## SINGAPOREAN NOTICES TO MARINERS

The monthly Notices to Mariners contain information required to keep charts and publications published by the Hydrographic Department, Maritime and Port Authority of Singapore up-to-date.

Block for Chart No 200

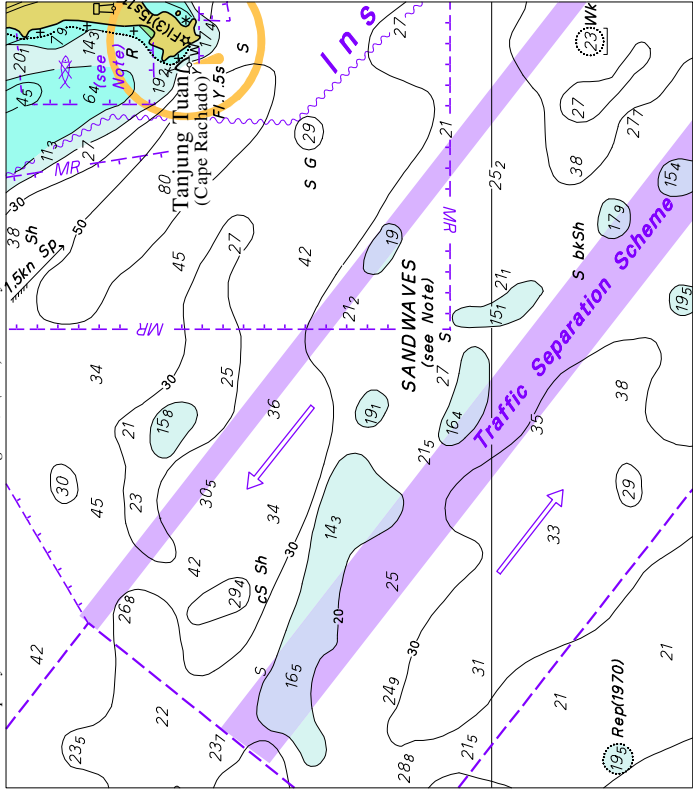
-----			
<b>202</b>	8 Ed 15/09/16 Last NM 94/2017	(Admiralty Notice No. 41/4748/17)	<b>NM 99/2017</b>
<b>Move</b>	 <b>Q.14M</b> from:		1°10·13'N 103°39·77'E
	to:		1°10·26'N 103°39·75'E
		(Maritime and Port Authority of Singapore)	<b>NM 103/2017</b>
<b>Insert</b>	Automatic Identification System, <b>AIS</b> , on lighthouse		1°19·81'N 104°24·34'E
-----

Block for Chart No 4039

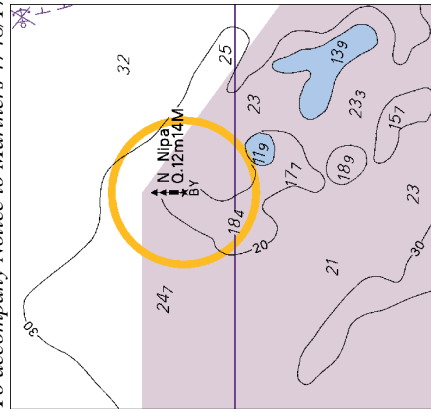
Insert	the accompanying block, centred on:	1°10·2'N	103°39·7'E
--------	-------------------------------------	----------	------------

Block for Chart No 4040

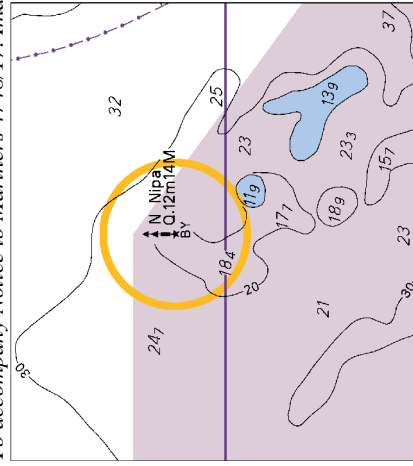
**Insert** the accompanying block, centred on: 1°10·2'N 103°39·8'E

CORRECTION NO.	SNM EDN NO.	LAST CORRNO NO.	CHART NO.	Location on Chart	
					X
<b>98</b>	<b>11/2017</b>	<b>97/2017</b>	<b>GSP1/SP1</b>

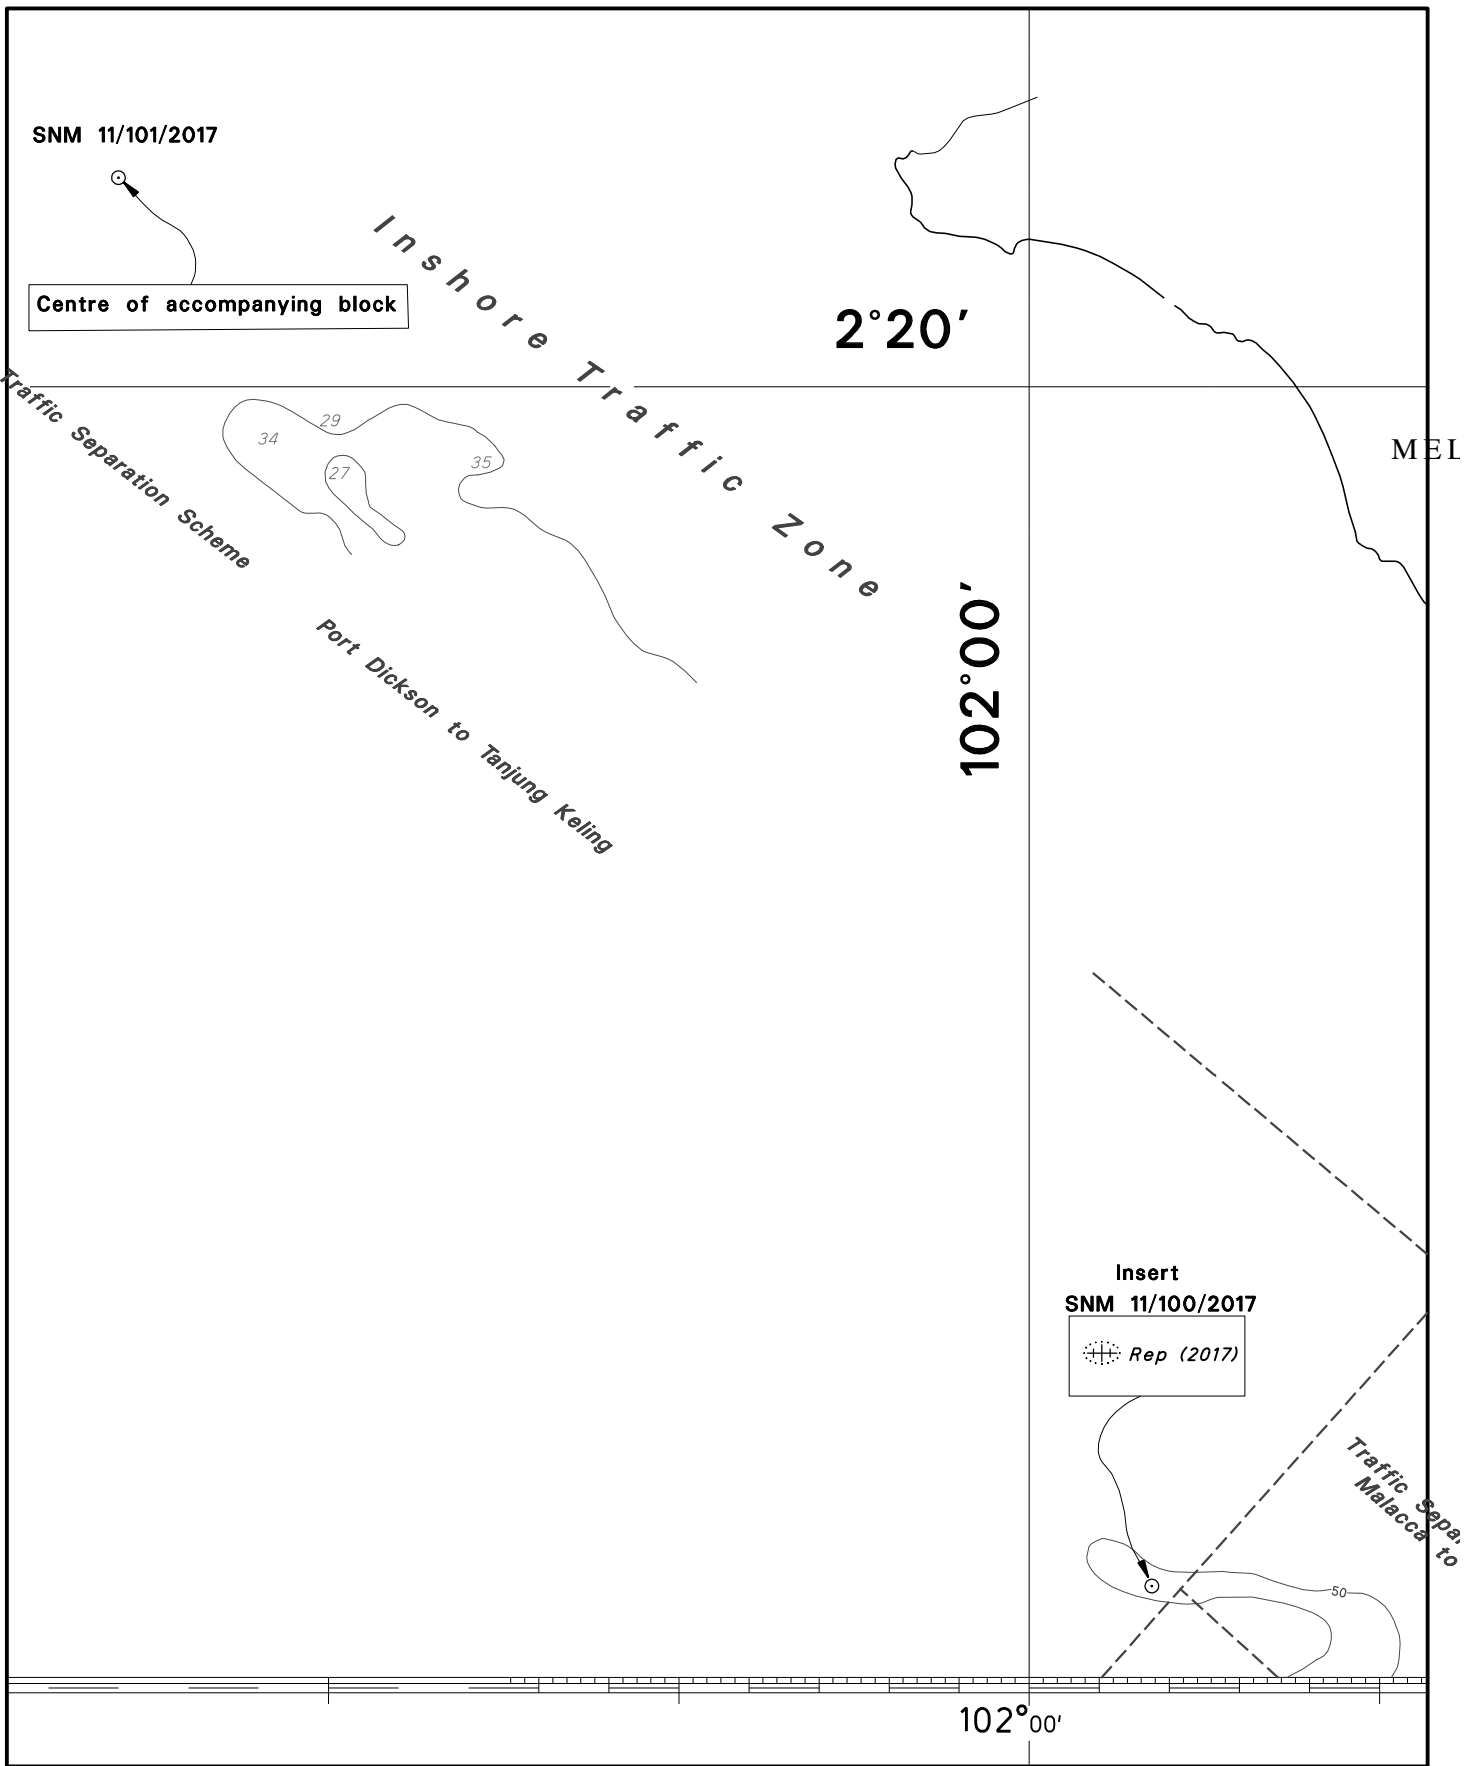
CC  
Fl.G.2s

Fl.G.2s2m3M

**Amend**  
**SNM 11/98/2017**

CORRECTION NO.	SNM EDN NO.	LAST CORR NO.	CHART NO.	Location on Chart
99, 102	11/2017	NE 15/9/2017	500	X

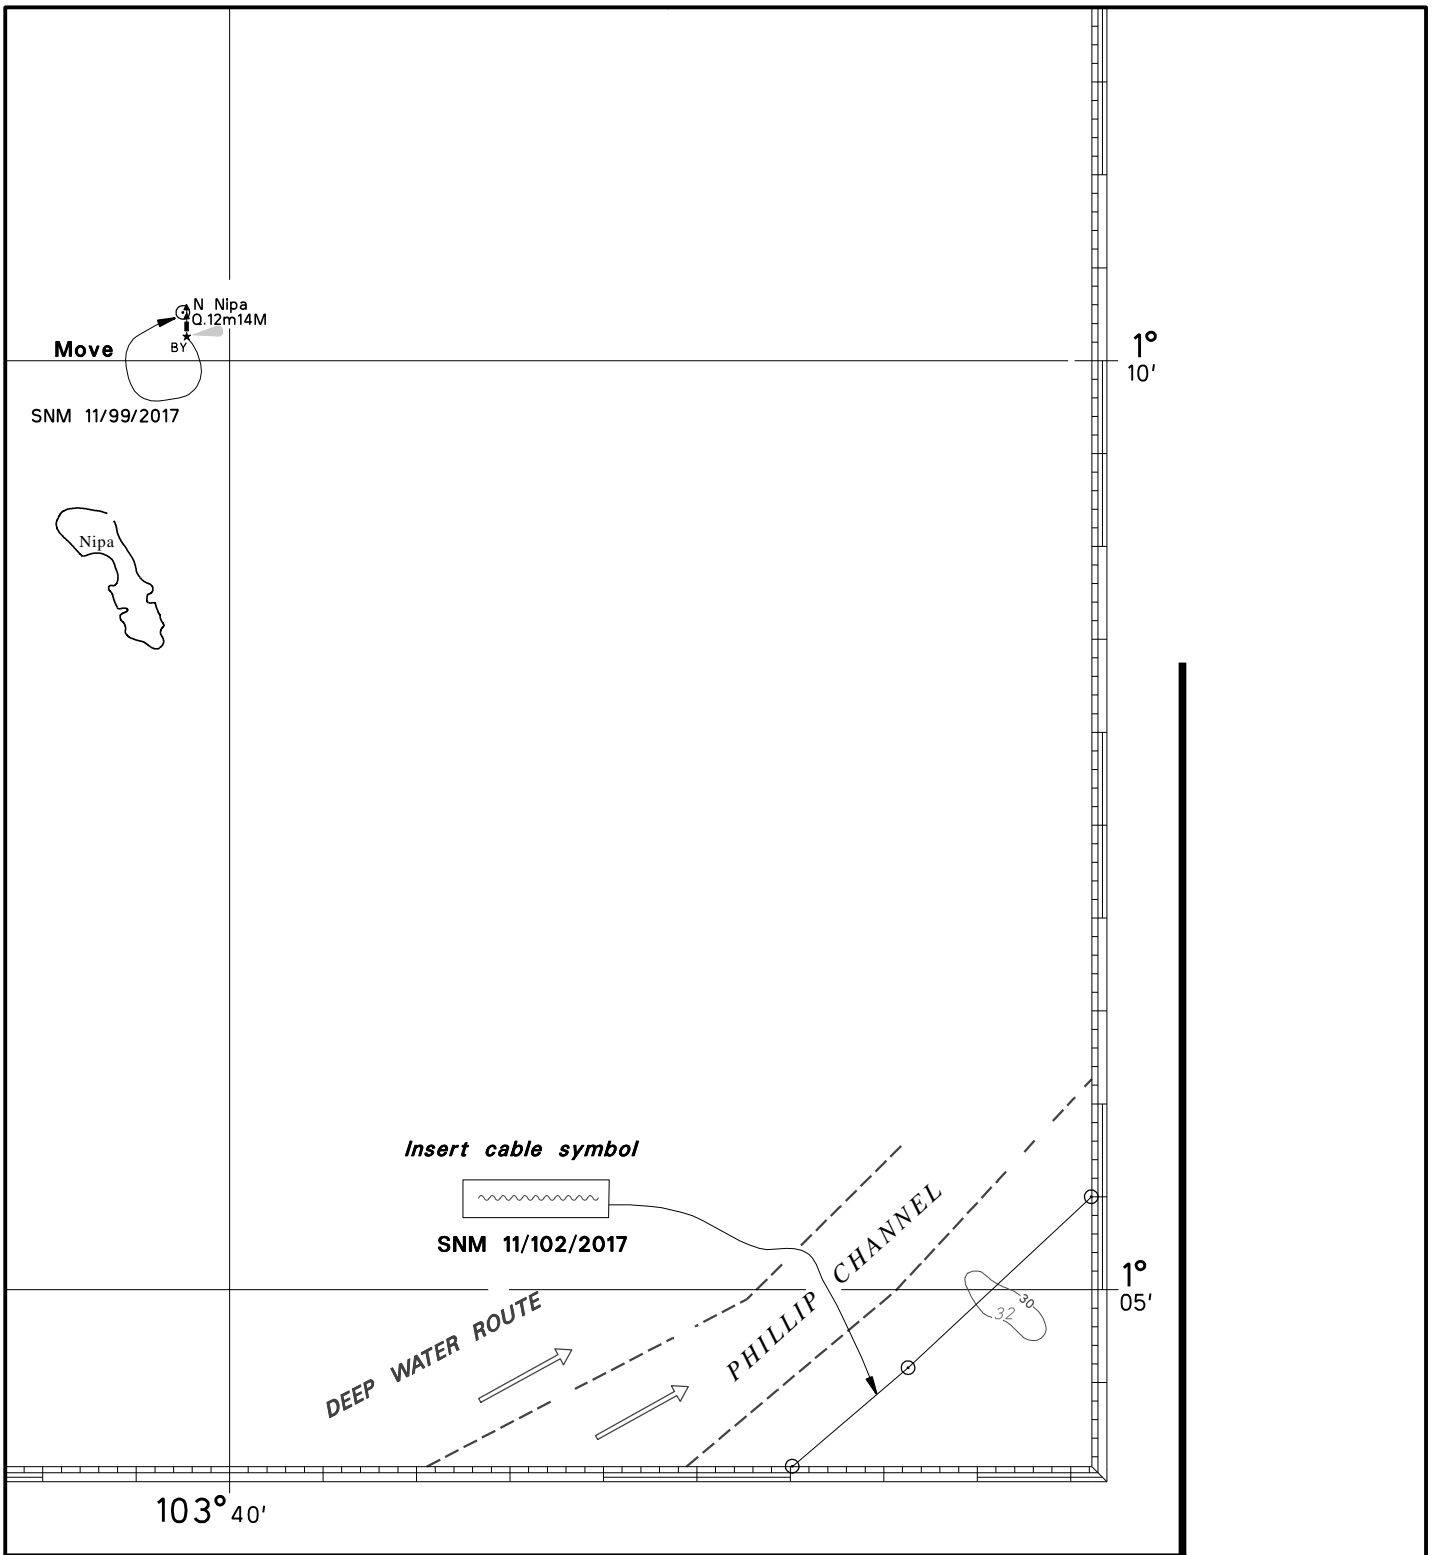
<b>500</b>	8 Ed 15/09/17	(Admiralty Notice No. 41/4748/17)	<b>NM 99/2017</b>
<b>Move</b>	 <b>N Nipa Q.12m14M</b>	from:	1°10·13'N 103°39·77'E
		to:	1°10·26'N 103°39·75'E
		(Indonesian Notice No. 36/552/17)	<b>NM 102/2017</b>
<b>Insert</b>	submarine cable,  , joining :		
		1°05·50'N	103°44·61'E
		(chart border)	
		1°04·58'N	103°43·63'E
		1°04·05'N	103°43·01'E
		(chart border)	
		and	
		1°04·05'N	103°34·89'E
		(chart border)	
		1°04·09'N	103°34·83'E
		1°04·05'N	103°34·77'E
		(chart border)	
<hr/>			
<b>501</b>	7 Ed 1/09/15 Last NM 79/2017	(Admiralty Notice No. 41/4748/17)	<b>NM 99/2017</b>
<b>Move</b>	 <b>N Nipa Q.12m14M</b>	from:	1°10·13'N 103°39·77'E
		to:	1°10·26'N 103°39·75'E
		(Indonesian Notice No. 36/552/17)	<b>NM 102/2017</b>
<b>Insert</b>	submarine cable,  , joining :		
		1°09·17'N	103°55·05'E
		1°09·87'N	103°54·30'E
		1°10·54'N	103°54·28'E
		1°10·83'N	103°53·02'E
		1°10·38'N	103°51·51'E
		1°09·68'N	103°50·90'E

CORRECTION NO.	SNM EDN NO.	LAST CORRNO.	CHART NO.	Location on Chart		
102	11/2017	NE 15/9/2017	500			
						X

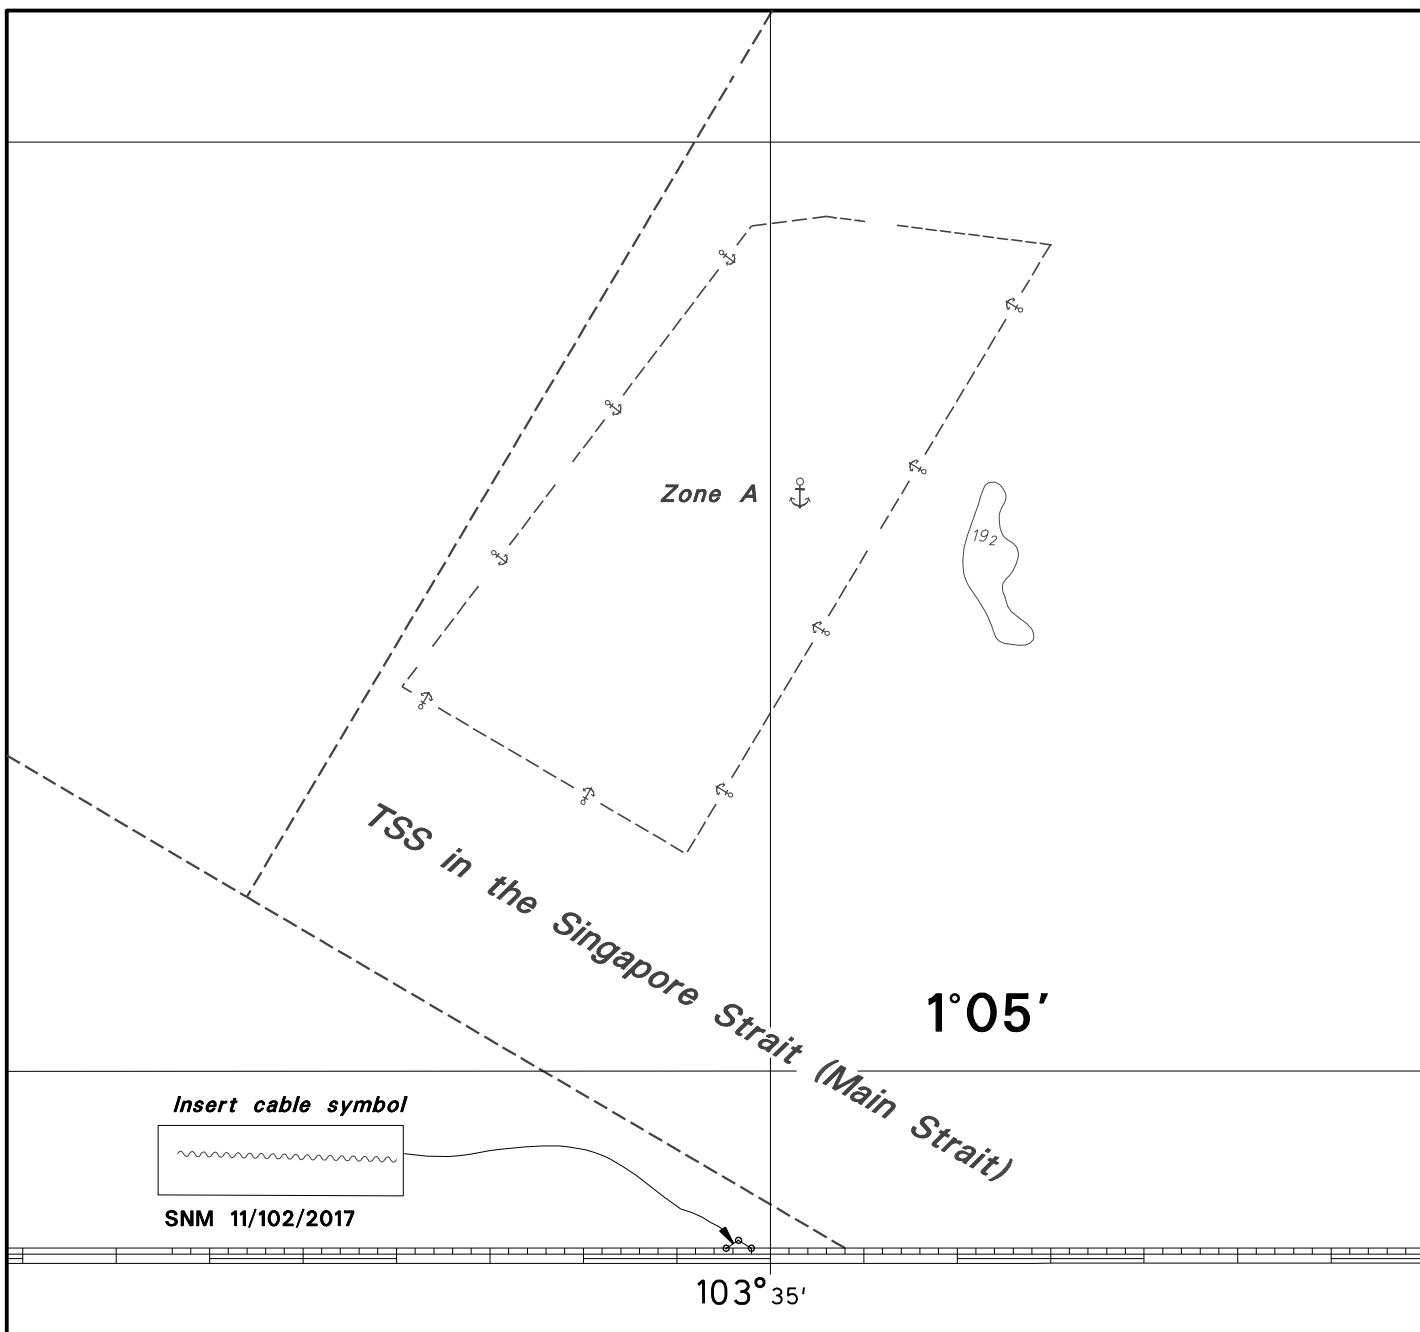
1°09·50'N	103°49·85'E
		1°08·82'N	103°48·82'E
		1°08·18'N	103°48·15'E
		1°07·96'N	103°46·84'E
		1°07·38'N	103°46·04'E
		1°06·61'N	103°45·80'E
		1°04·58'N	103°43·63'E
		1°01·58'N	103°40·14'E
		1°01·45'N	103°39·07'E
		1°04·09'N	103°34·83'E
		1°02·52'N	103°32·38'E
		0°59·44'N	103°32·30'E
		0°59·42'N	103°29·28'E
		0°59·44'N	103°29·17'E
		(chart border)
